**FINAL DRAINAGE REPORT
FOR
STERLING RANCH RECYCLING FACILITY**

**August 2023
Project No. 25188.14
PCD Filing No: PPR-23-XXX**

PPR2341 & SF2325

PROPOSED DRAINAGE MAP

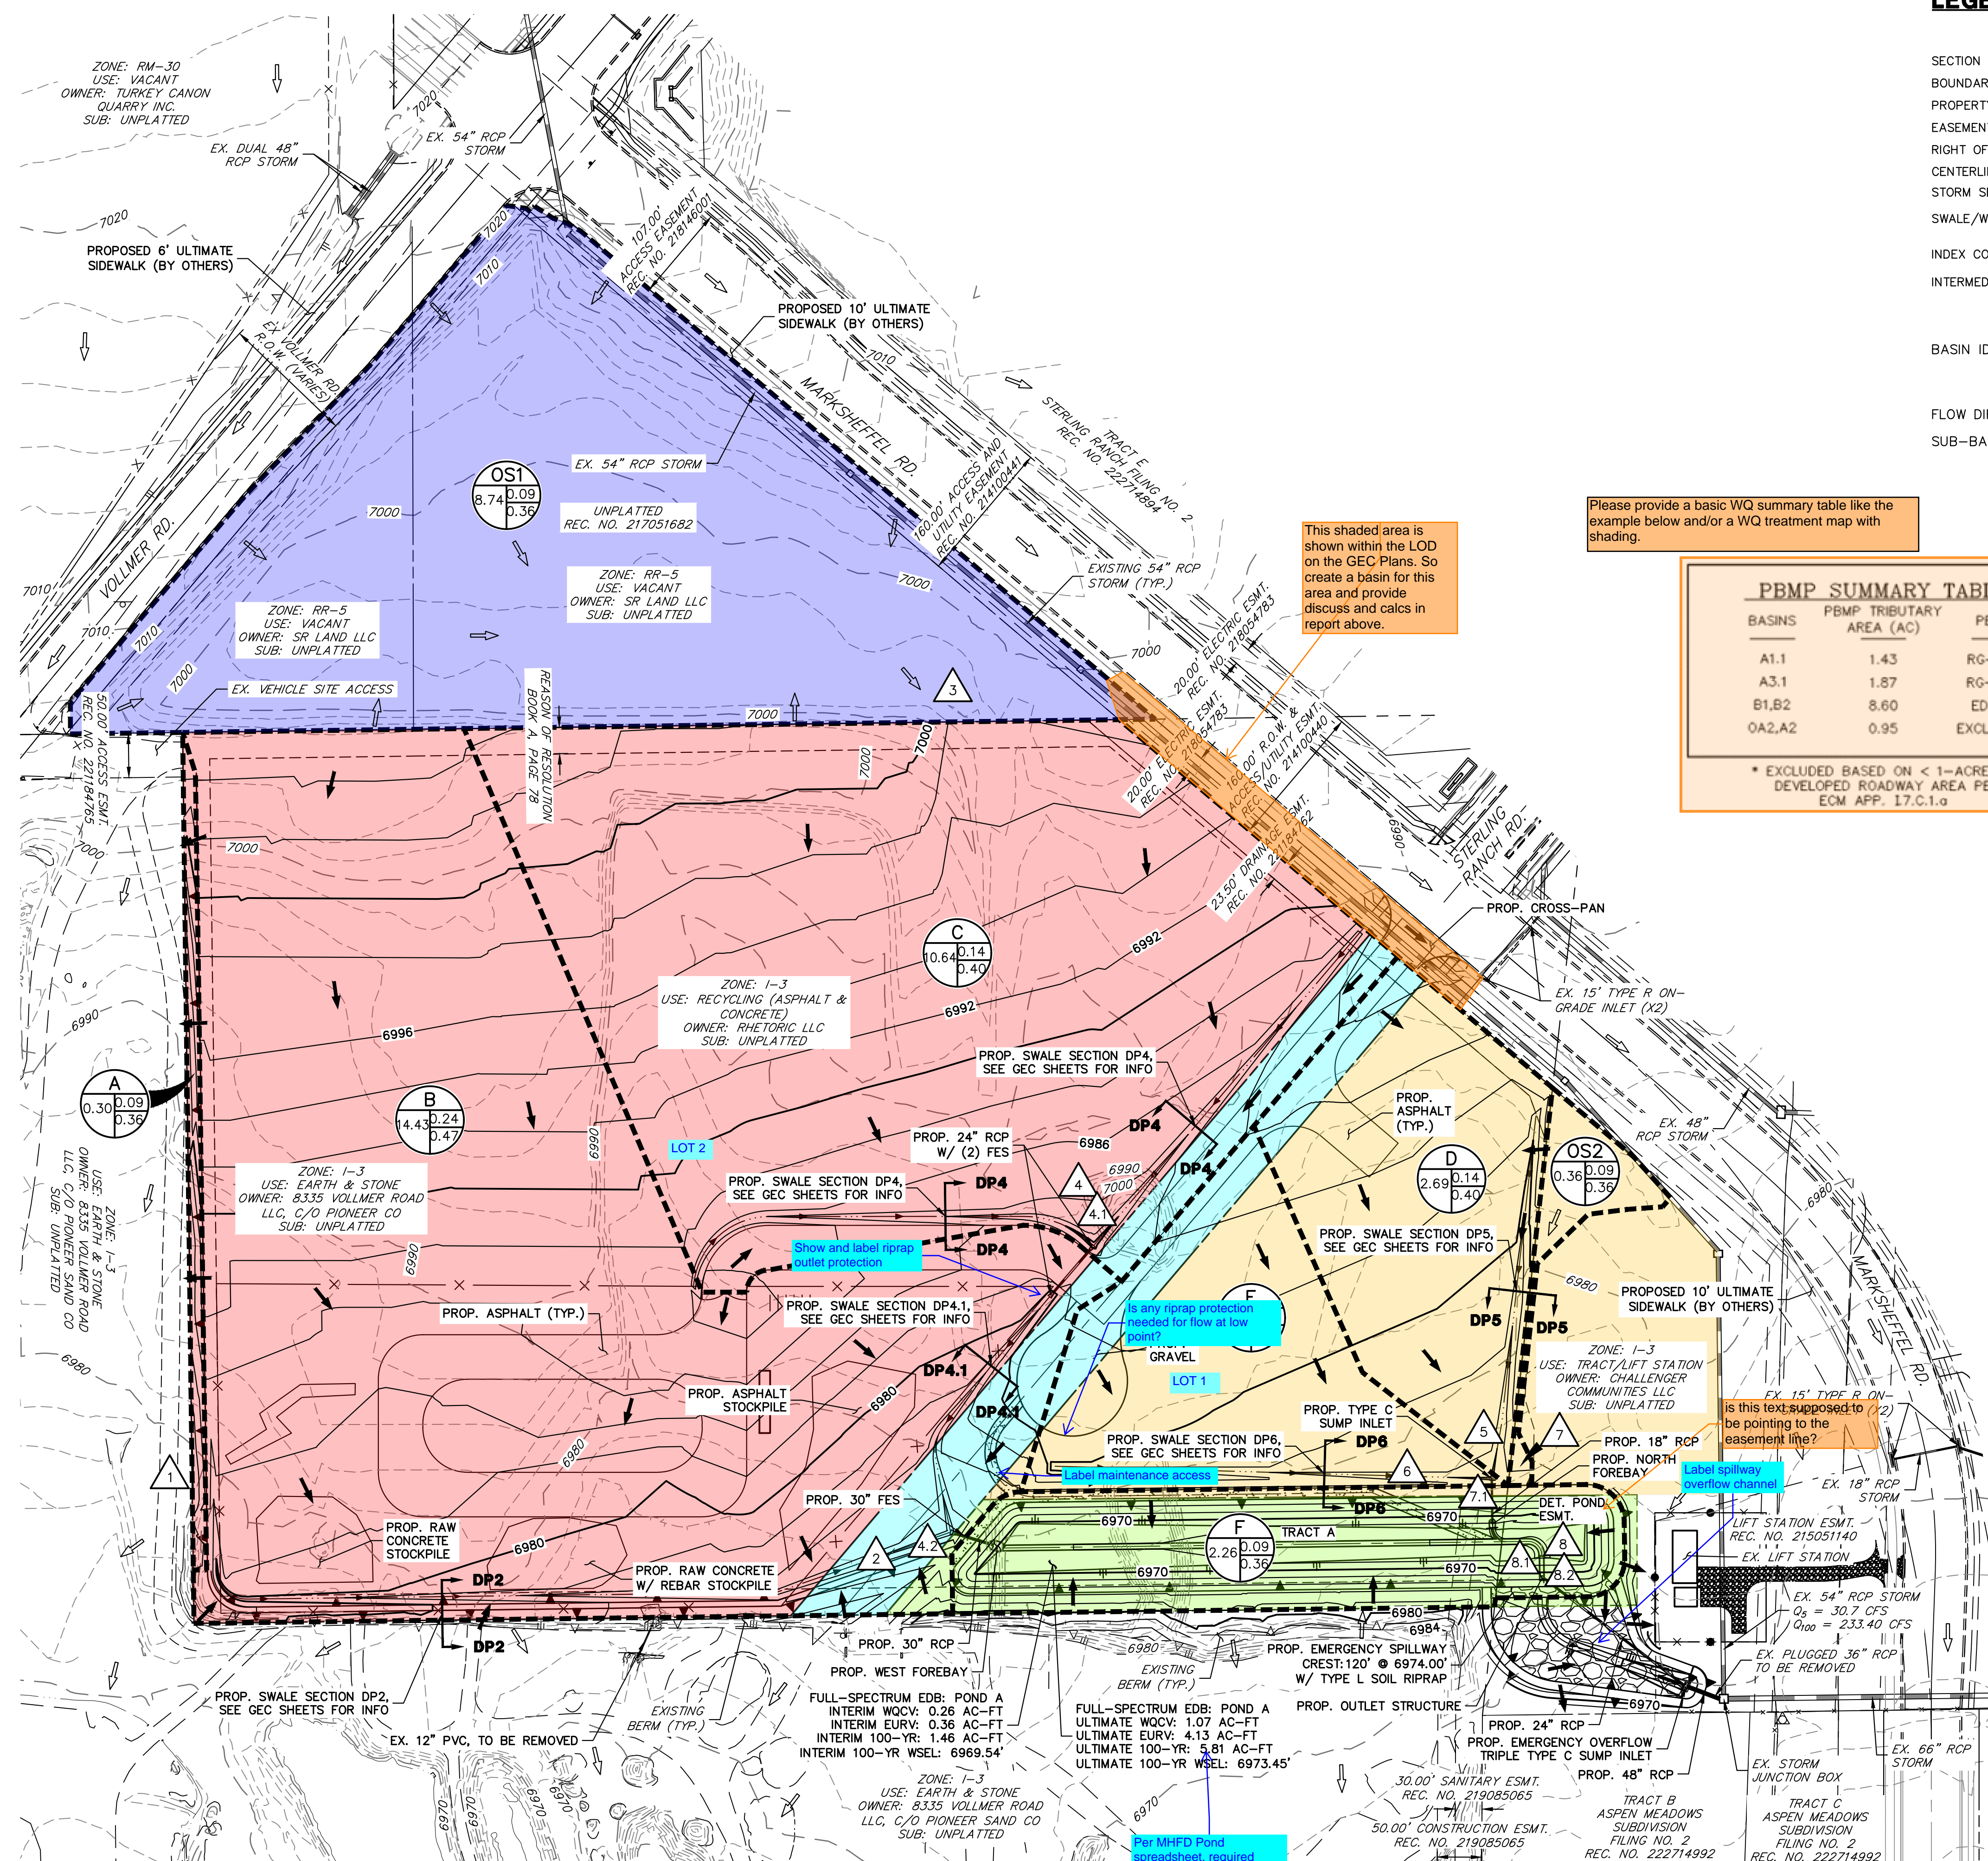
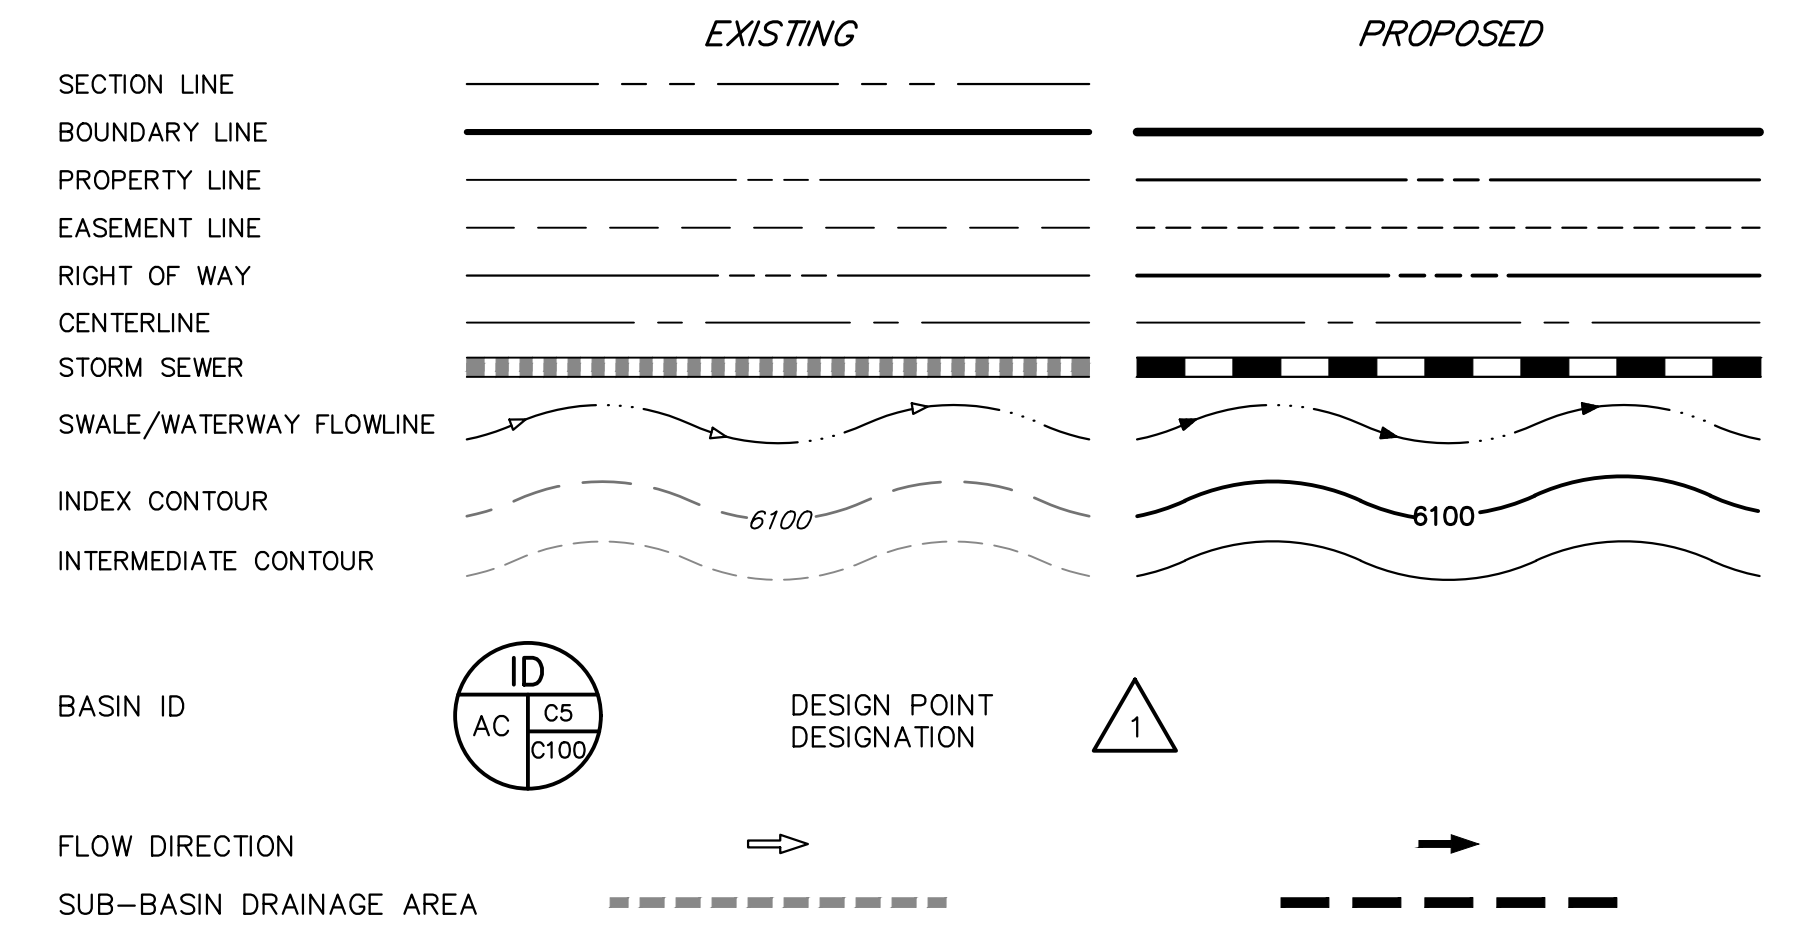
Please provide a basic WQ summary table like the example below and/or a WQ treatment map with shading.
